PROJECT NO. PR-2021-006070
Application No. SI-2021-01888

DESCRIPTION: Comment response memo, revised plan set, and infrastructure list.

Memorandum

Re: Westpointe40 South Site Plan DRB Comment Responses (PR-2021-006070)

BLUE SKY DISTRIBUTING ALBUQUERQUE, NM	DRAWN BY AS
	FIRE ONE PLAN AVALON SUBDIVISION UNIT 5	DATE 9-8-21
	5571 MIDWAY PARK PL. NE ALBUQUERQUE, NEW MEXICO 87109 (505) 858-3100 www.tierrawestllc.com	DRAWING 2021062-FO
RONALD R. BOHANNAN P.E. #7868	9-16-21	SHEET # FO-1
		JOB # 2021062

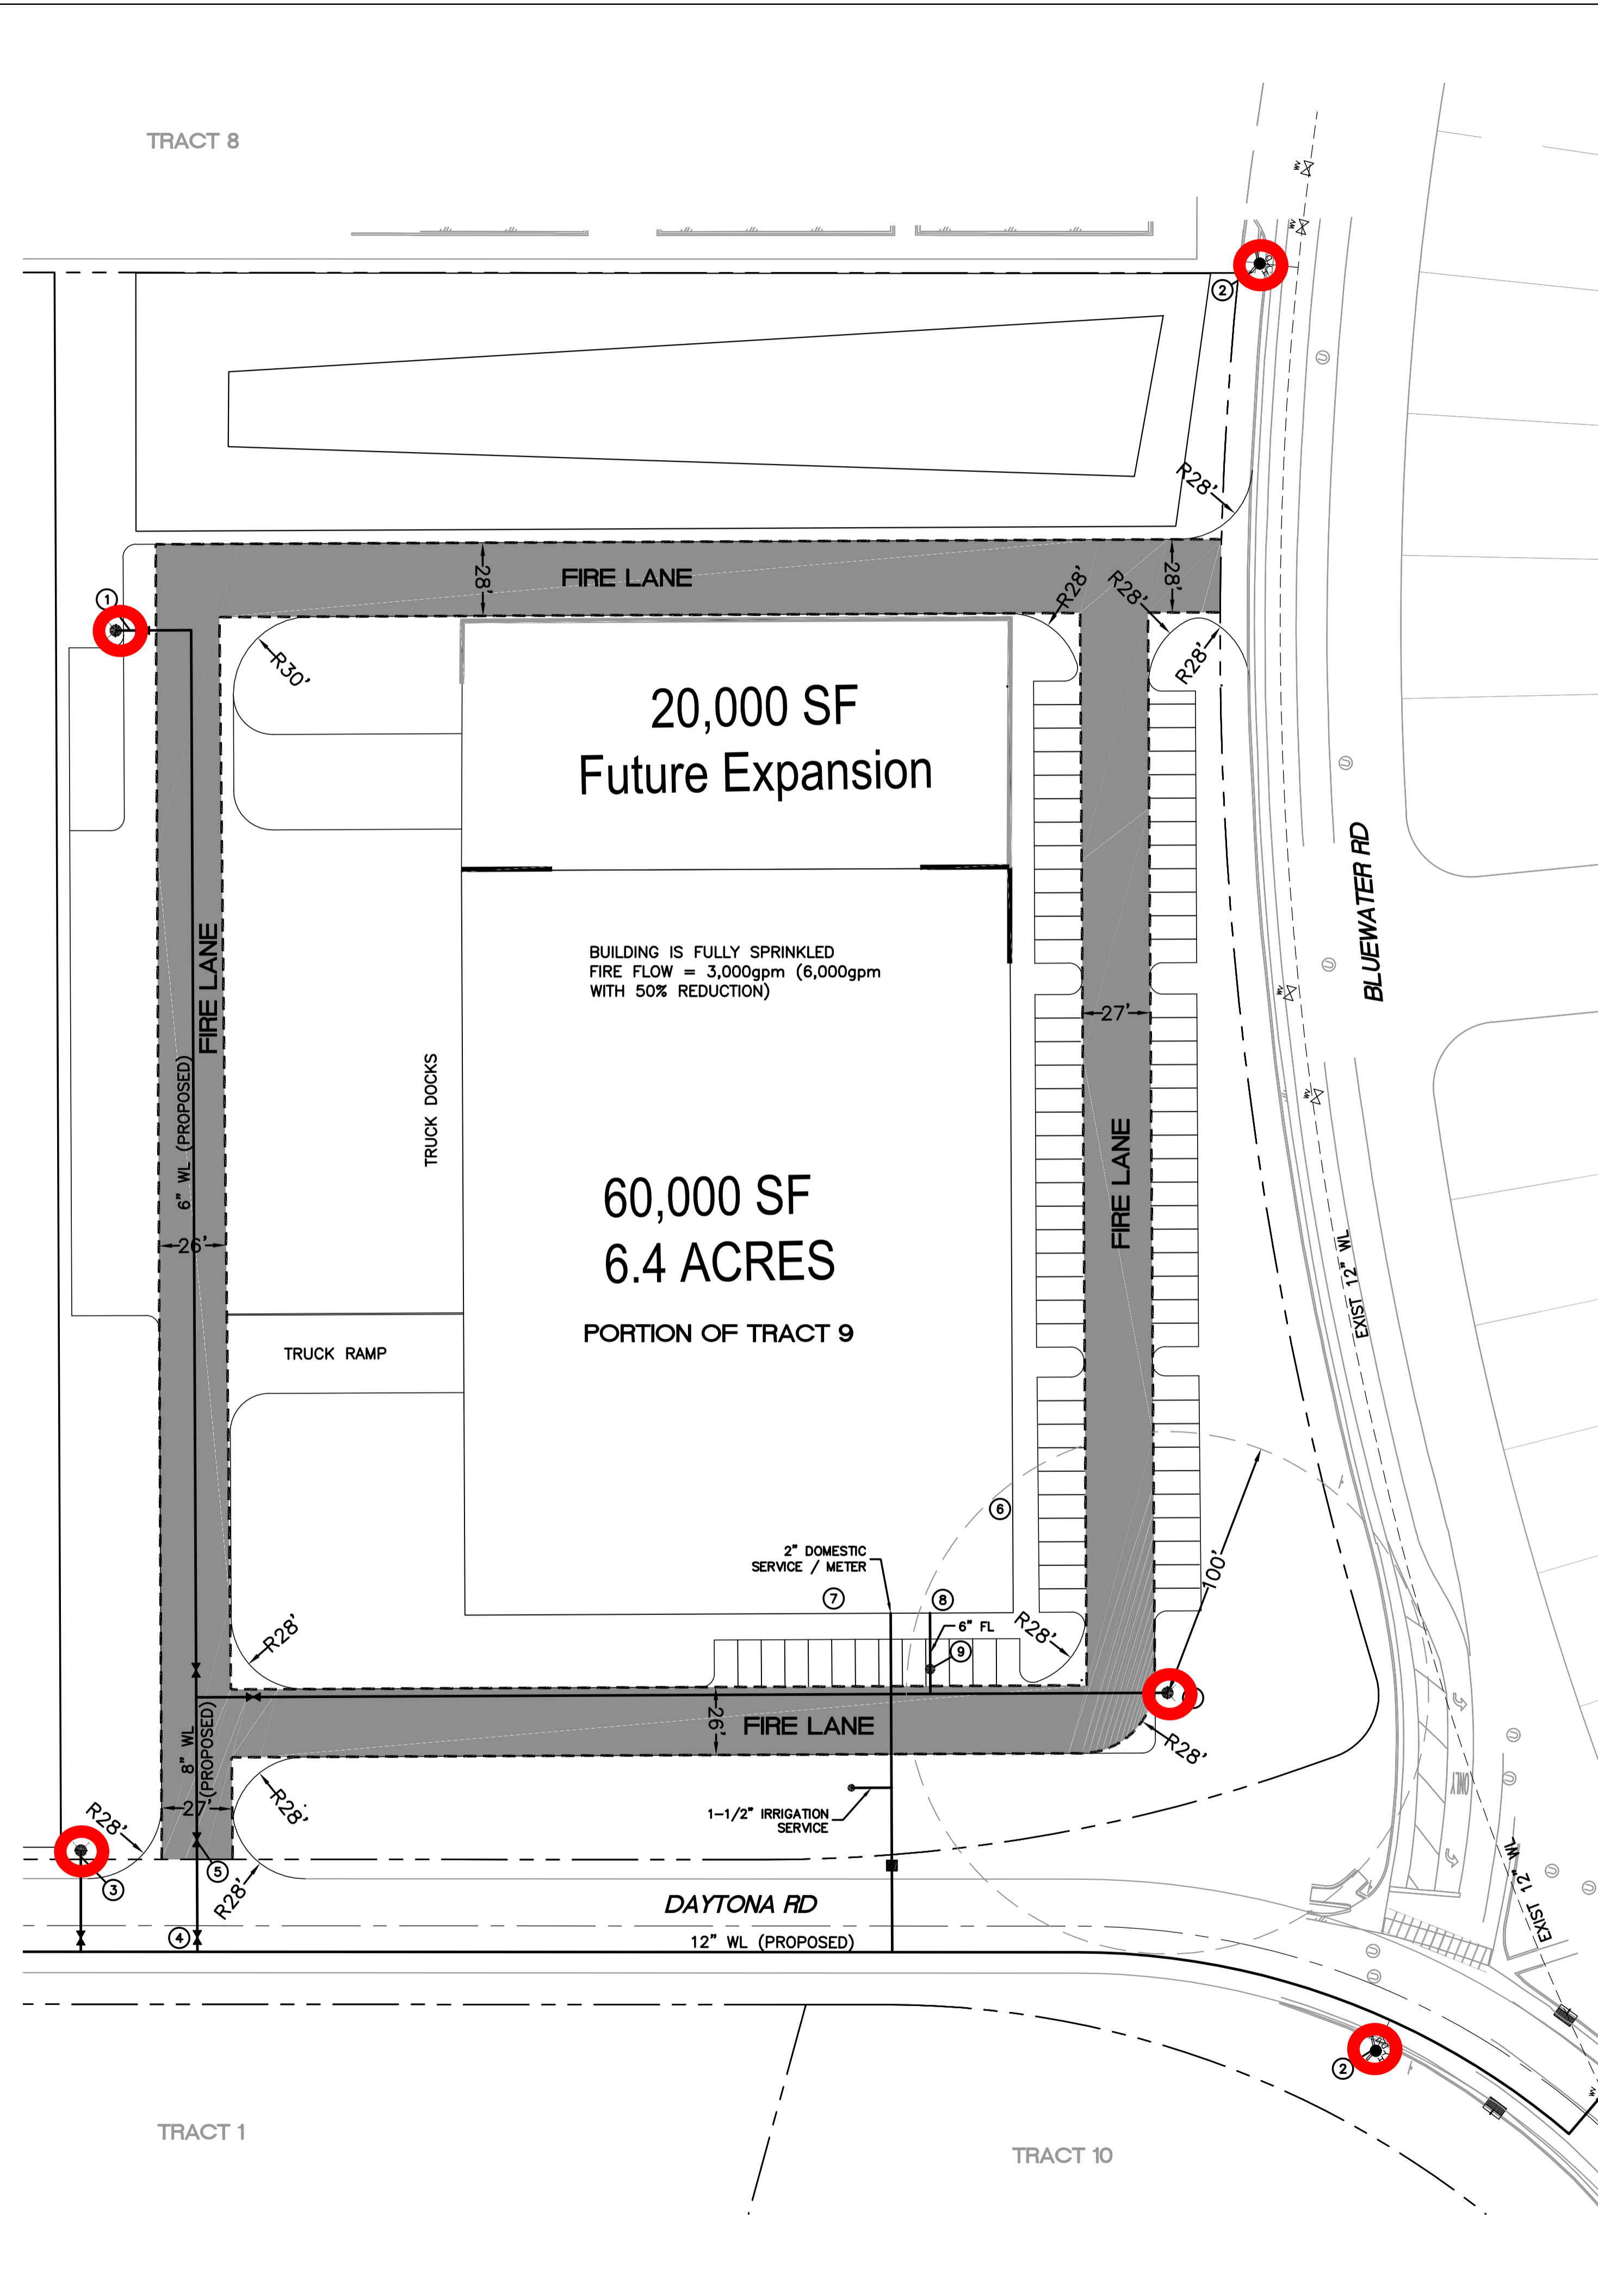
3. Obtain Fire-1 plan for the submittal set.
 - *The approved Fire 1 plan has been added to the attached plan set.*
4. Include the sidewalk detail in the Det-1 sheet, showing a 2% maximum cross-slope.

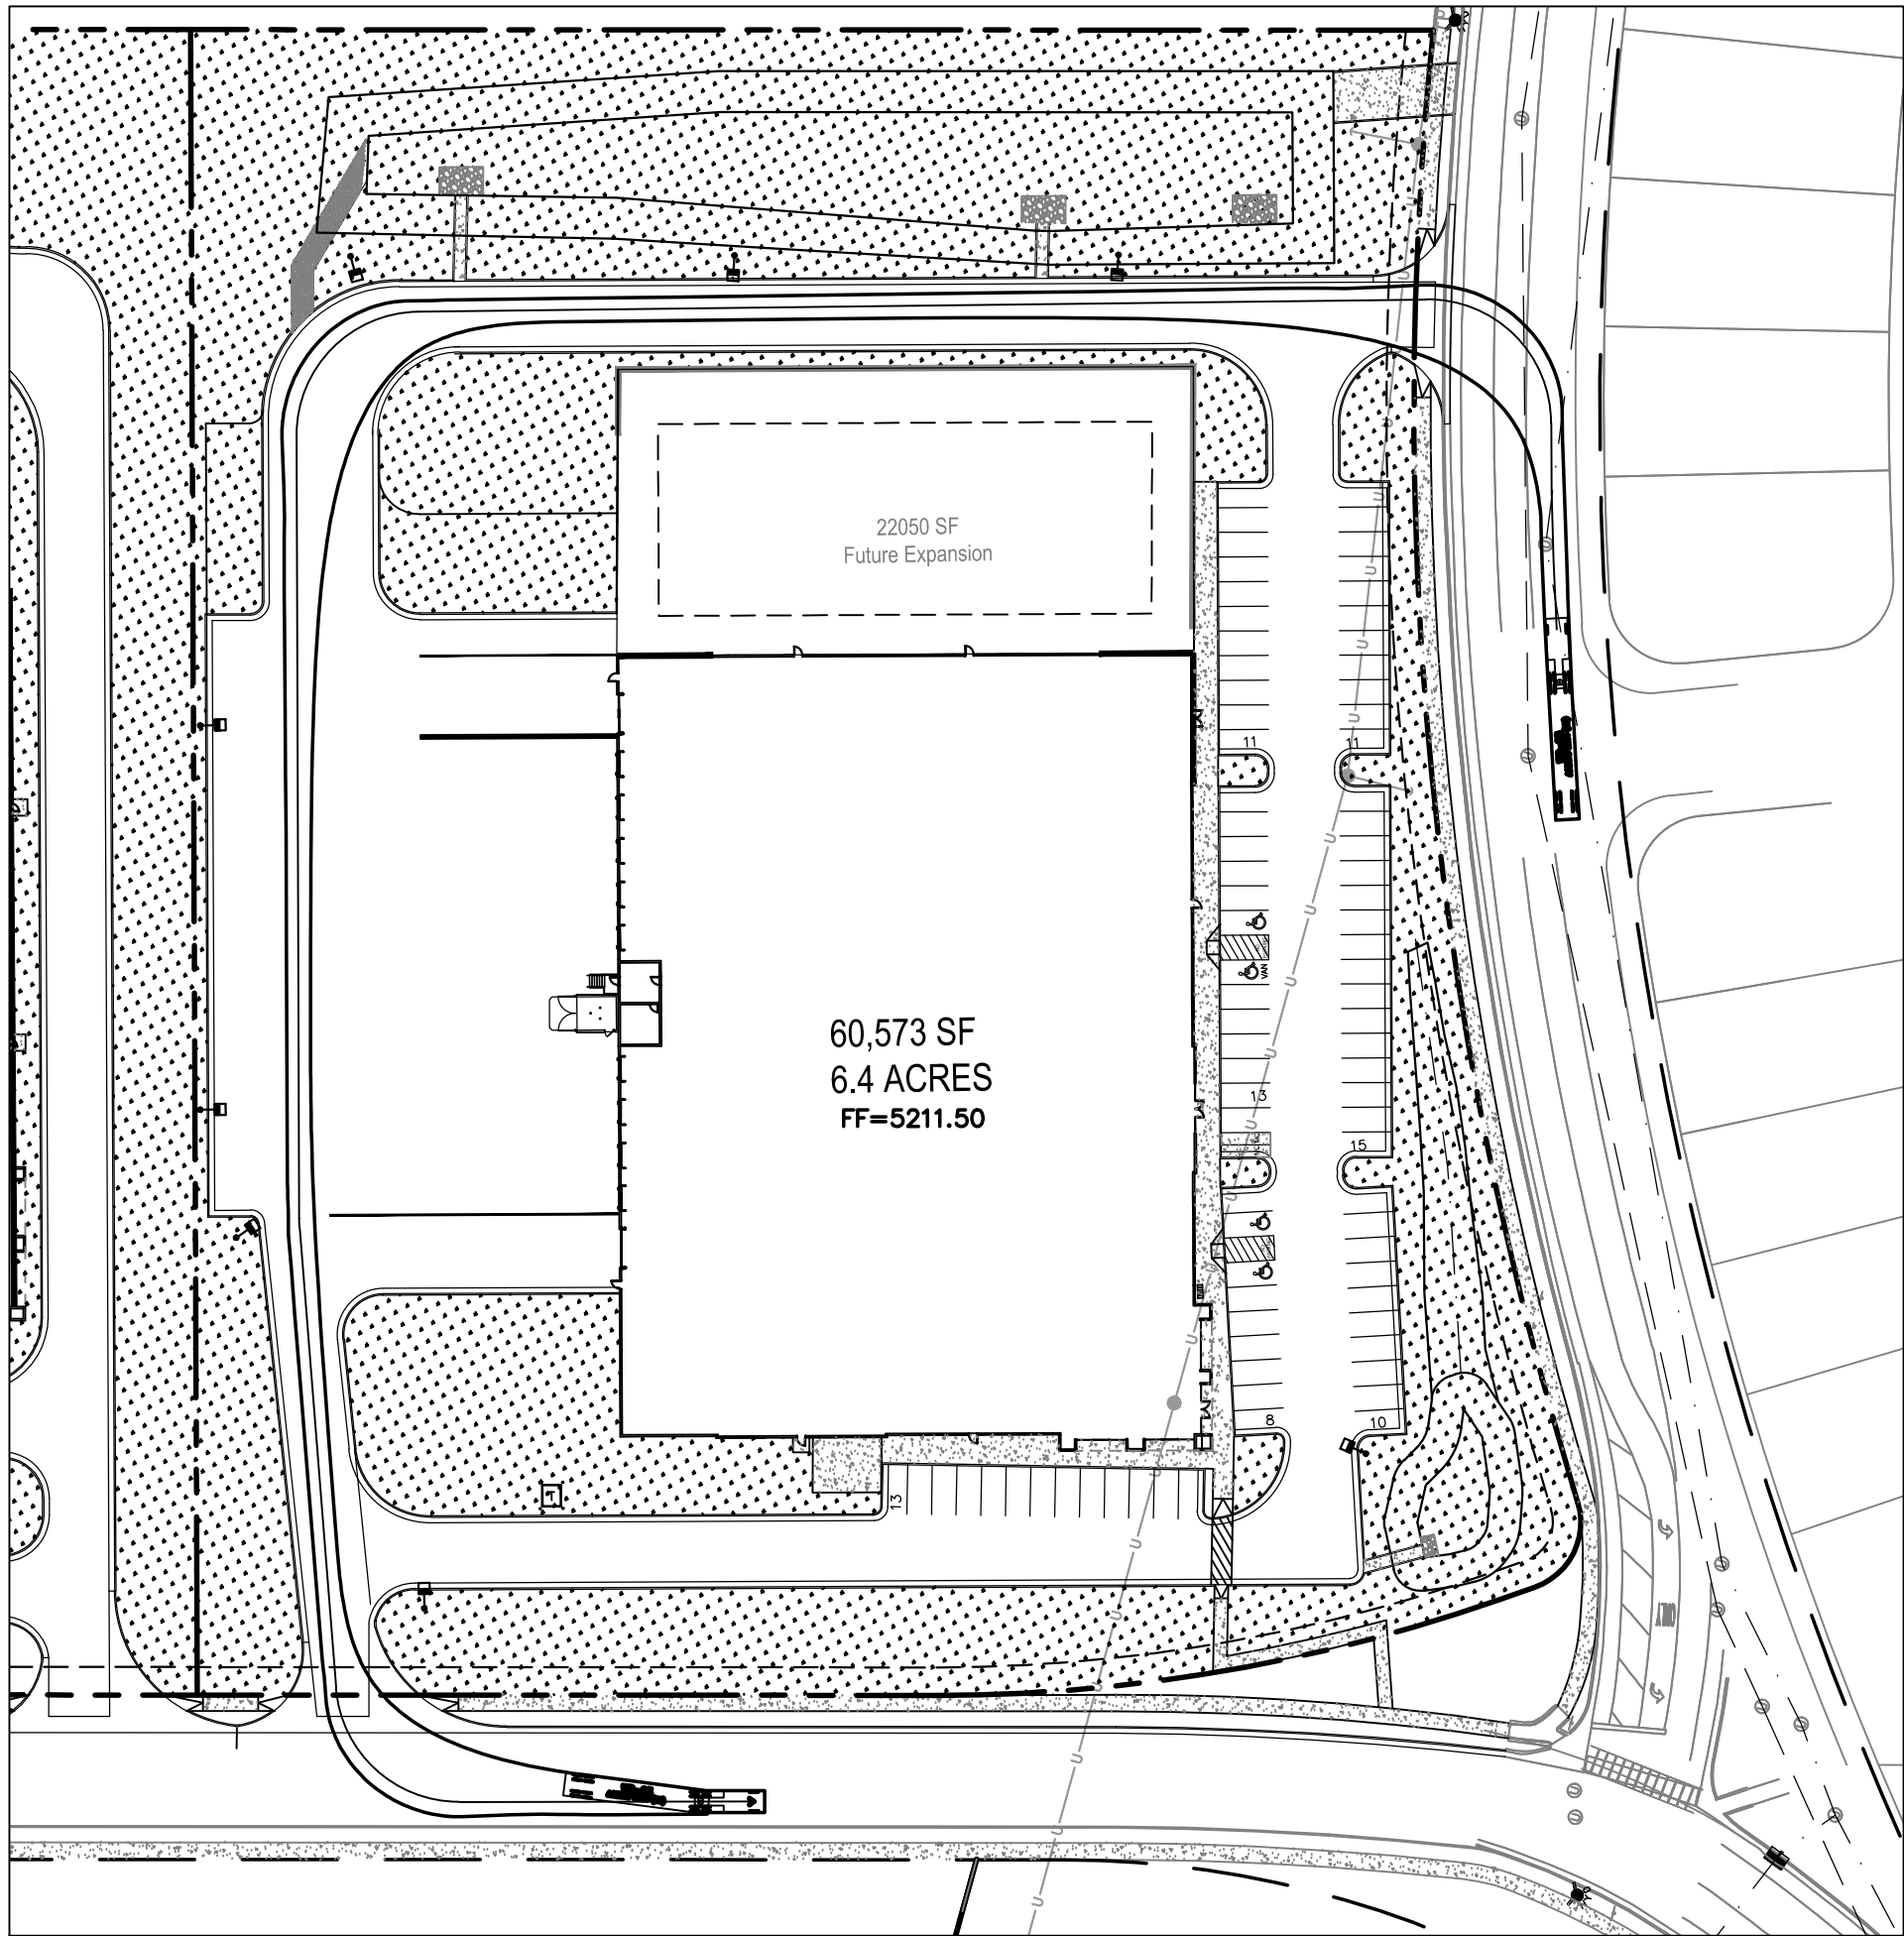
1. Based on the turning template provided, there is minor overlap between truck turning movements and the curb. Radii appear to need adjustment at the 90-degree bends, and it appears that the entrance off of Bluewater shall need to be modified to accommodate the turning movements.

- *The radii have been adjusted slightly on the Site Plan and updated turning template exhibits are provided.*
2. On the cross-section shown, the minimum width for a bike lane is 5 feet without the curb, and the minimum required vehicular lane width is 11 feet. Make any adjustments as needed.
